RESOLUTION HOLDING HEARING ON REQUEST FROM KENYON HILL RIDGE, LLC FOR THE 1ST AMENDMENT TO THE RUBY ROSE RIDGE PUD CONCEPTUAL PLAN FOR PROPERTY LOCATED IN THE VICINITY OF 2401 EAST 50TH COURT

Communication from the City Plan and Zoning Commission advising that at their September 16, 2021 meeting, the following action was taken regarding a request from Kenyon Hill Ridge, LLC (owner), represented by Dean Quirk (officer), for review and approval of the 1st amendment to the Ruby Rose Ridge PUD Conceptual Plan, for property located in the vicinity of 2401 East 50th Court, to allow development the 6.27-acre "Area C" with approximately 65 housing units within approximately 11 rowhouse residential structures.

RUBY ROSE RIDGE PLANNED UNIT DEVELOPMENT

1 OF 6

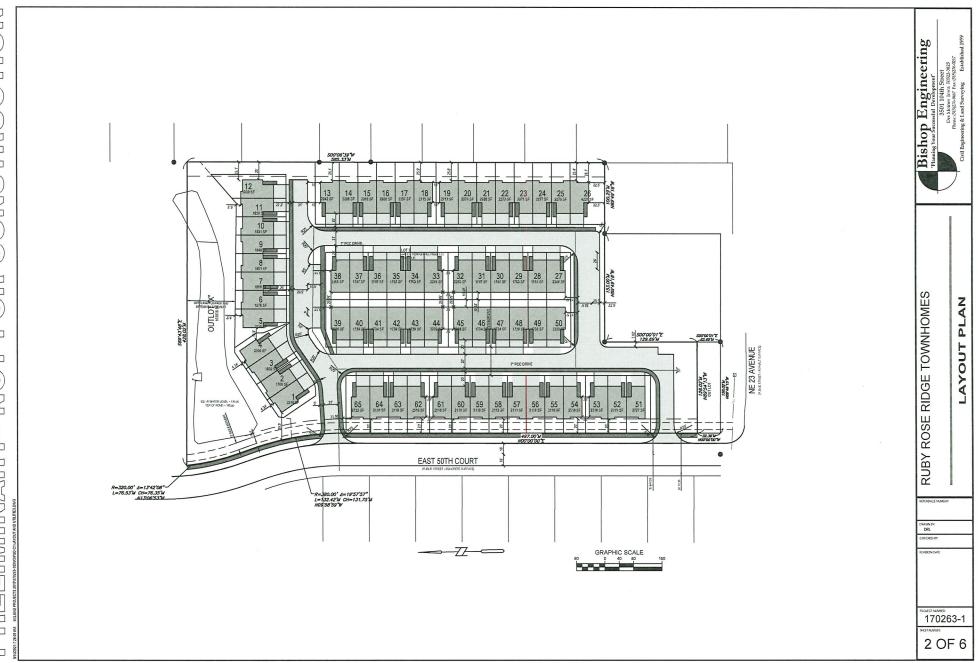
The submittal indicates these standards are from those applicable in the NX2 District for this type of development. The NX2 District limits building coverage area to a maximum of 45% with total impervious area (building & pavement) to 65% for Row Building and Flat Building Types. Staff believes that the Conceptual Plan should be corrected to match the correct code reference.

- **4. Landscaping:** The landscaping standards listed on the submitted amendment focus on Areas A & B and do not address Area C. Staff believes that foundation plantings should be provided for each rowhouse unit and that the overall site should be landscaped in accordance with the applicable standards found in Chapter 135 of City Code.

Staff recommends that the PUD Conceptual Plan state the developer is responsible for all costs and connection fees associated with the sanitary sewer connections and all costs associated with constructing the necessary water connections.

Staff recommends that the PUD Conceptual Plan state all utilities shall be provided underground, where reasonably practicable, in accordance with Chapter 135: Planning and Design Code.

Staff recommends that the PUD specify sidewalk to be provided along East 50th Court and Easton Boulevard inclusive of the existing one household home that fronts NE 23rd Avenue.

shall have black vinyl-cladding. Staff recommends that the standards in Chapter 135 be referenced for fencing in Area C.

The PUD Conceptual Plan does not address how mechanical or similar equipment is to be handled. Staff recommends that the PUD state that mechanical, meters, transformers or similar shall be screened and shall not be located on a street-facing façade.

APPROVAL of the "Ruby Rose Ridge" PUD Conceptual Plan subject to the following revisions:

1. Replacement of the proposed maximum building coverage standard for Area C with a statement indicating that building coverage and imperious area maximums shall be regulated by the applicable rowhouse standards found in Chapter 135: Planning and Design Ordinance.

- 2. Provision of a note that states foundation plantings shall be provided for each rowhouse unit.
- Provision of a note that states Area C shall be landscaped to meet and/or exceed the applicable landscaping standards found in Chapter 135: Planning and Design Ordinance.

- 4. Provision of a note that states that the developer is responsible for all costs and connection fees associated with the sanitary sewer connections and all costs associated with constructing the necessary water connections.

- 5. Provision of a note that states all utilities shall be provided underground, where reasonably practicable, in accordance with Chapter 135: Planning and Design Ordinance.

- 6. Provision of a note that states sidewalk shall be provided along East 50th Court and Northeast 23rd Avenue (Easton Boulevard) including the frontage along the adjoining outlot and Lot 1.

- 7. Provision of a note that states fencing within Area C shall comply the applicable standards found in Chapter 135: Planning and Design Ordinance, with any permitted chain link fencing being limited to black vinyl clad.

- 8. Provision of a note that states that trash and recycling for Area C shall be residential roll outs in nature and shall not be located within a setback or on a street-facing façade.

- 9. Provision of a note that states mechanical, meters, transformers or similar items shall be screened and shall not be located on a street-facing façade.

- 10. The front façade of any rowhome constructed on Lots 51-65 shall be oriented towards East 50th Court. These units shall utilize a rear loaded garage design. Each unit shall have a direct sidewalk connection to the public sidewalk along East 50th Court.

- 11. Provision of a note that states each rowhouse shall have an attached garage.
- 12. Provision of a note that states any building constructed in Area C shall comply with the applicable architectural design standards found in Chapter 135: Planning and Design Ordinance. (ZONG-2021-000016)
